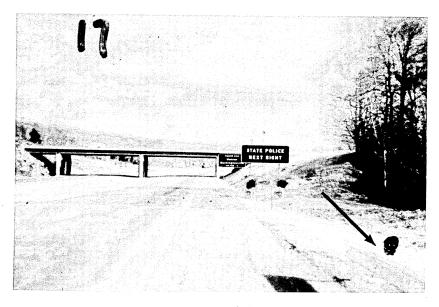
Here is a sign on Route 17, in New York State, and it says: "State police next right." You know that is not a critical sign. You could back it up where the dot is on your right (arrow) behind the rail and clear the area.

Like I say, the important thing is to make this area off limits and to make it hard for anyone to put signs here.

If they have to get through channels to get permission to put these signs here, they might look around and they might see that there is a guardrail here or a bridge abutment.

Here you can see you have an opportunity of putting that sign where the red dot is on the wall (arrow). They put this concrete stanchion in the gore which is the worst possible place. It would cost less to do the job right.
